ADDENDUM NO. 1

ORO GRANDE PARK REVITALIZATION PROJECT

PROJECT NO.: 30.30.0150

May 1, 2024

B PICKLEBALL COURT LAYOUT

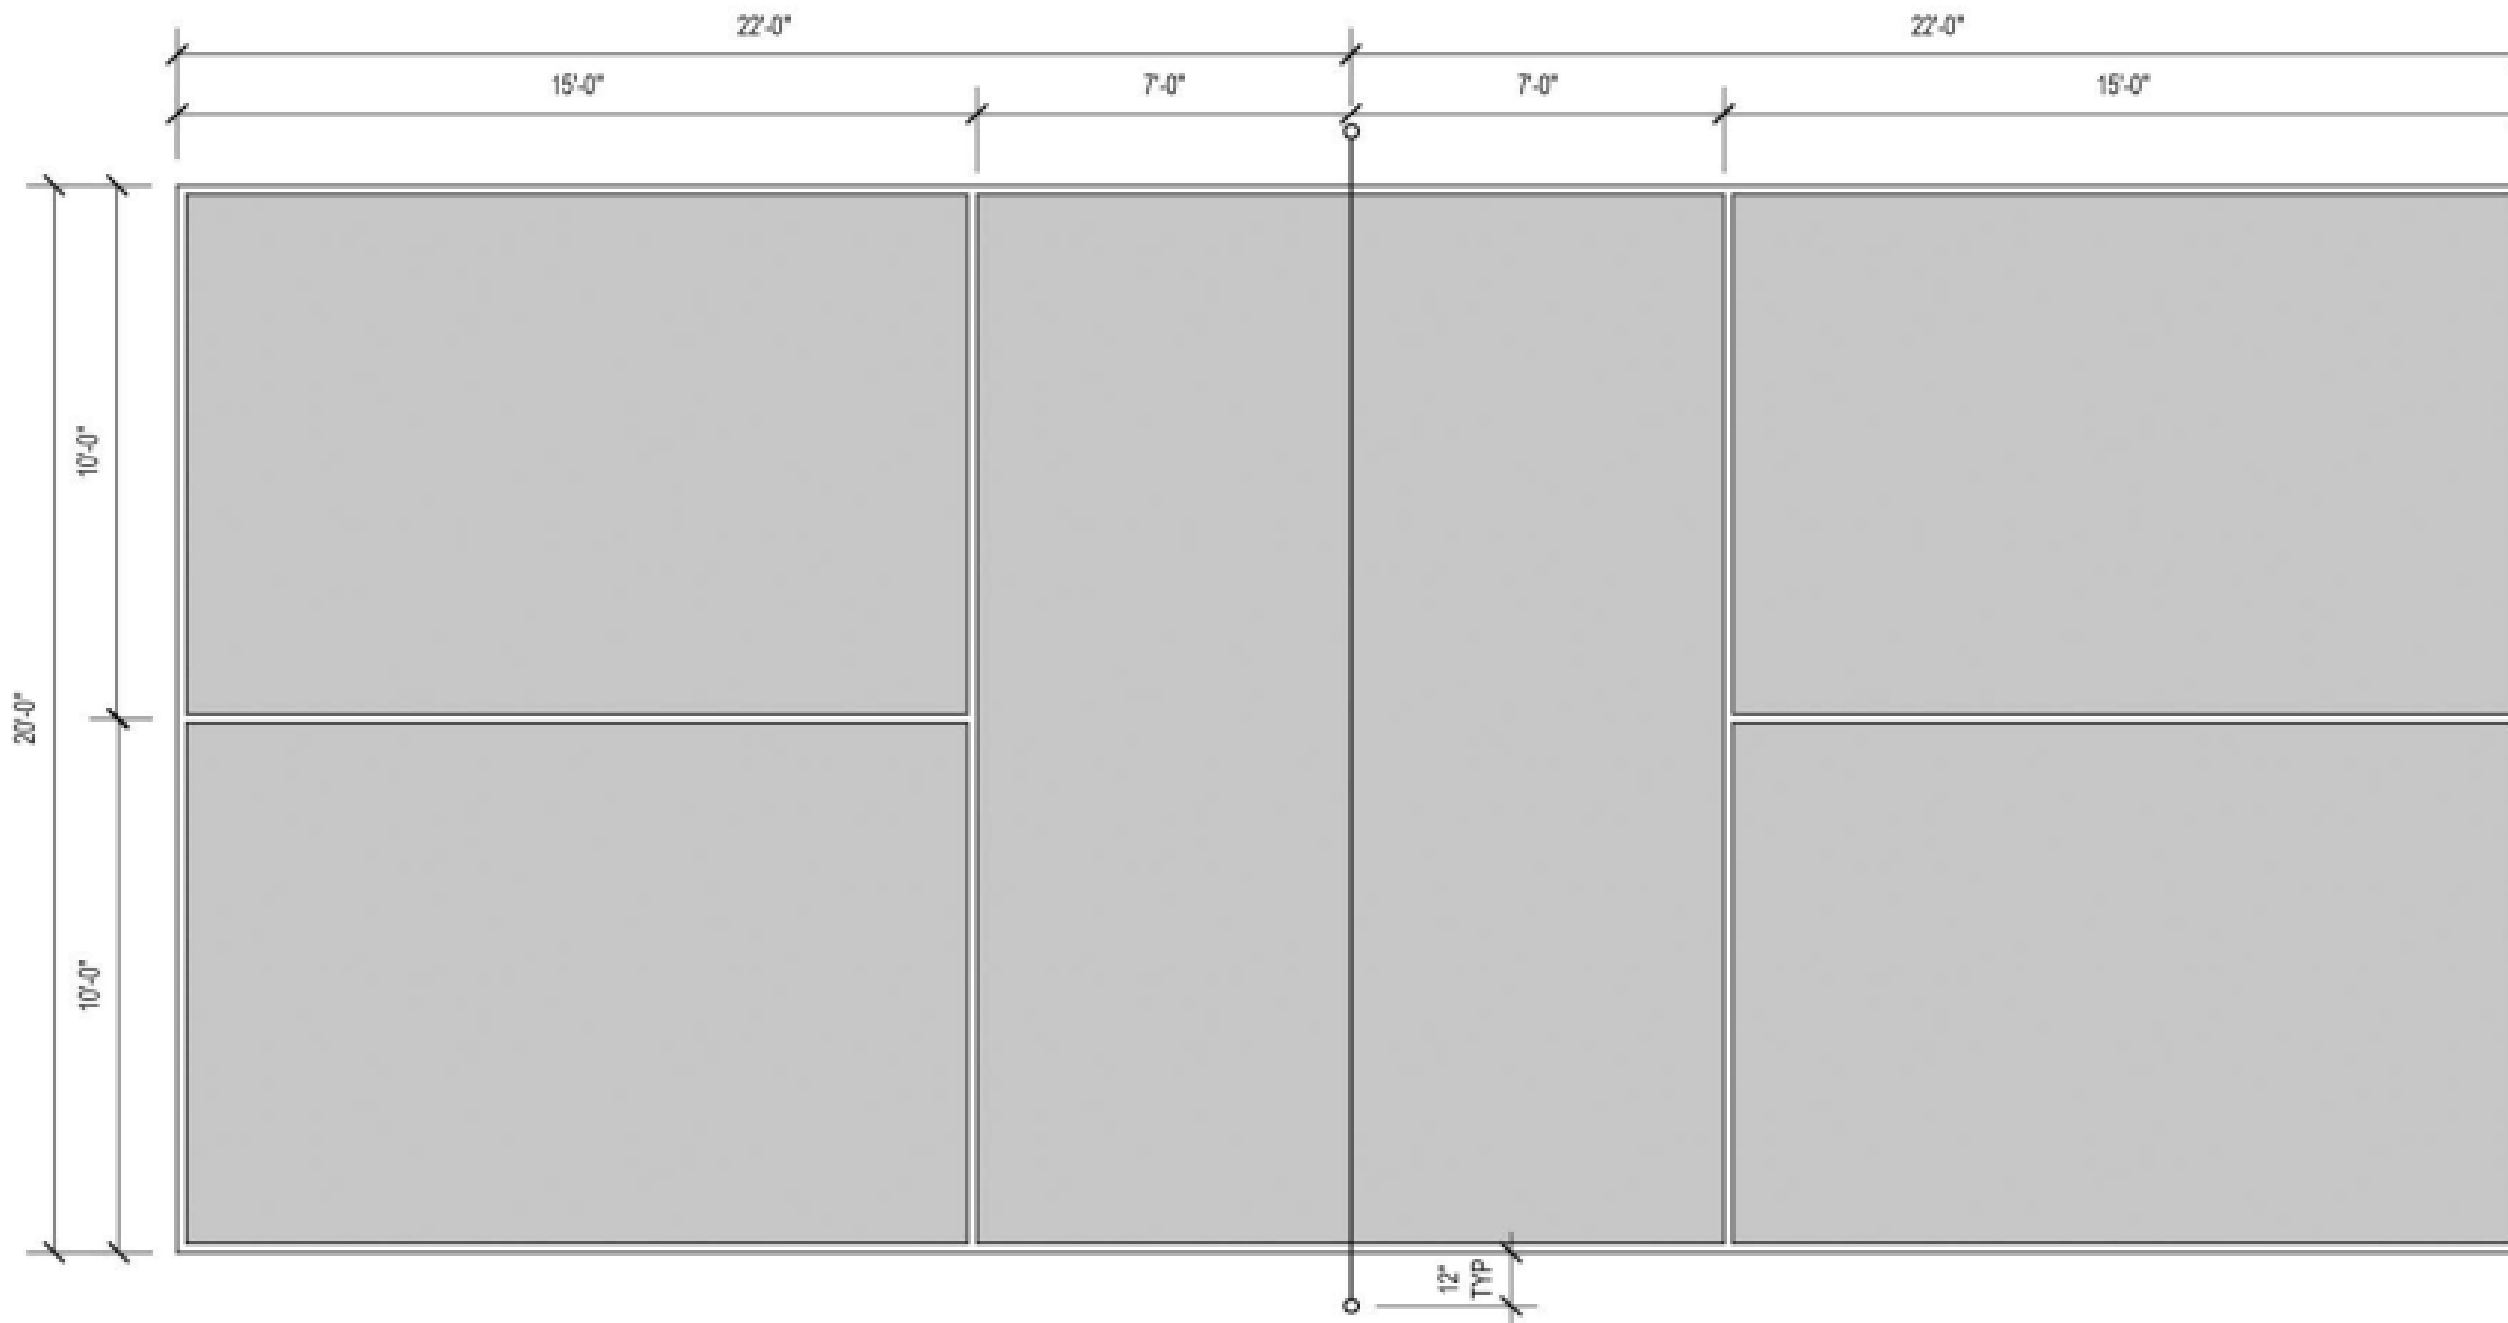
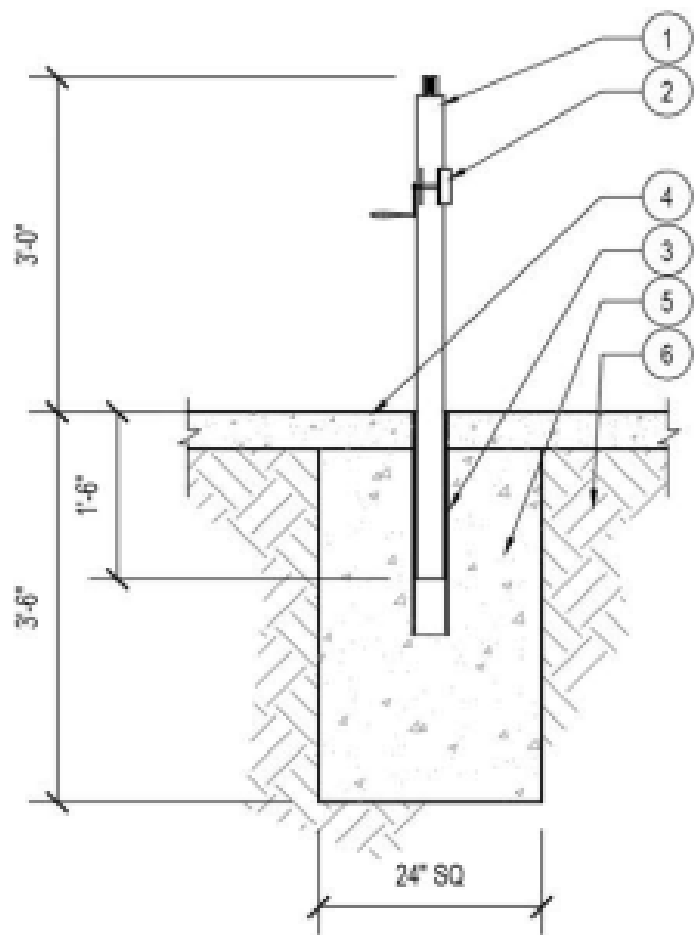
Answer: Plexipave manufactured by California Sports Surfaces is an additional manufacturer per the attached approved substitution request for the Latexite Plush Recreational Coating stipulated in Section H – Future Pickleball Court Layout.

- Pickleball court to be concrete, 4" thick and reinforced.
- Court to be full depth waterproof blue court with green perimeter and white lines. Finish to be smooth.
- Material color to be Latexite Plush Recreational Coating manufactured by Latexite. Contractor to submit color samples for approval prior to ordering
